ILLINOIS POWER COMPANY

November 30, 1981

Clinton Power Station Unit 1
Docket No. 50-461

Attached are details related to the following items which were discussed with James Lazevnick, Power System Branch, during a meeting of November 30, 1981 to resolve issues for the Clinton SER:

CONTAINMENT BUILDING
POLAR CRANE 1HC01G
BREAKER & RELAY SETTINGS

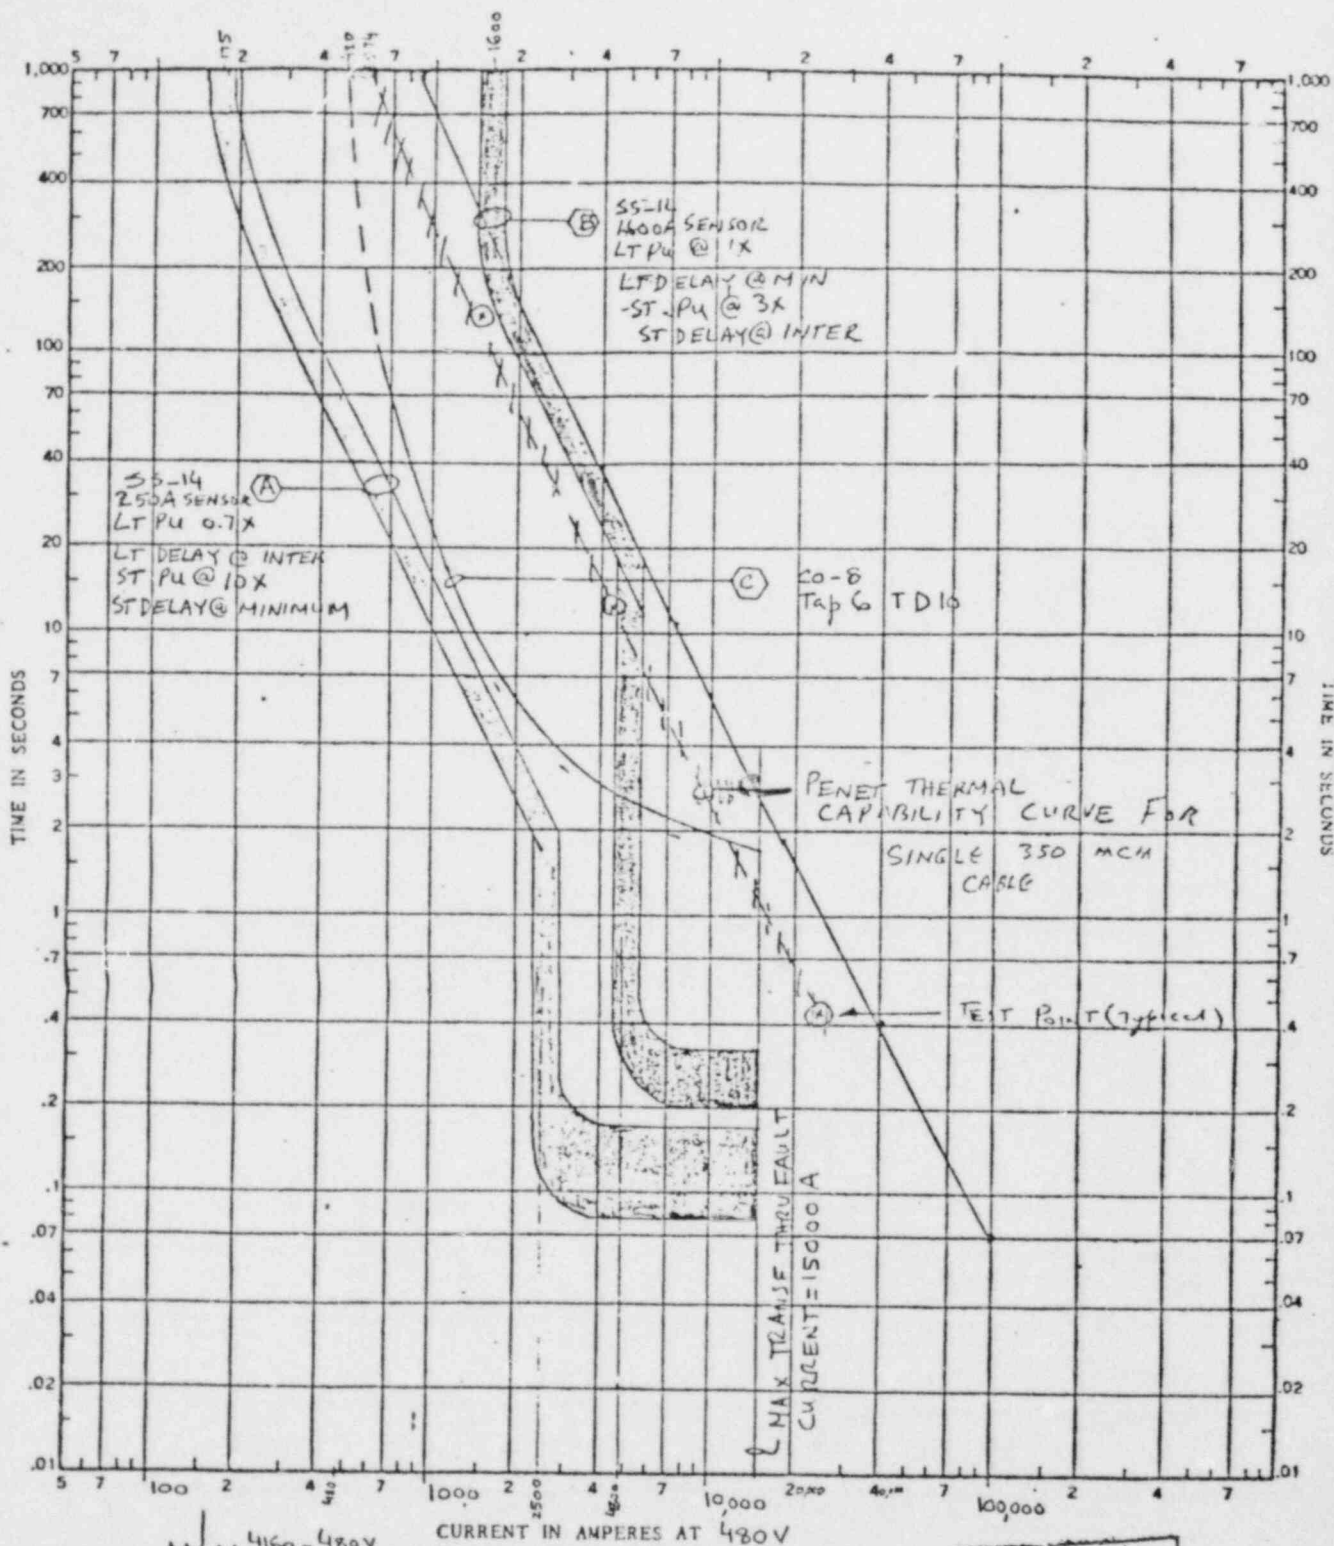
The scheme for protection of the Containment Building polar crane utilizes primary protection consisting of a 480 volt class 1E feeder breaker with a solid state trip device. Backup protection is provided by the class 1E main feed breaker to the 480 volt bus which is tripped by an inverse time-overcurrent relay we will require in the Technical Specifications that the feeder breaker to the crane be locked open during reactor operation.

The attached graph shows the thermal capability curve for a single 350 MCM penetration feedthru. Also shown plotted on the graph are coordination curves representing actual settings for the polar crane CO-8 overcurrent relay and the primary breaker SS-14 solid state trip device.

The graph shows that the coordination curves for both the CO-8 and SS-14 are well below the withstand capability curve of a single 350 MCM cable.

The current input at rated horsepower output of the polar crane is much less than the single 350 MCM cable thermal capability. Should the loss of one of the penetration parallel 350 MCM conductors occur, both the SS-14 and the CO-8 will adequately protect the remaining 350 MCM cable within the containment penetration.

Therefore, it is not necessary to lock open the polar crane feeder breaker during reactor operation and, as agreed, IP rescinds its earlier commitment to add Tech Spec surveillance requirements on this feeder breaker.
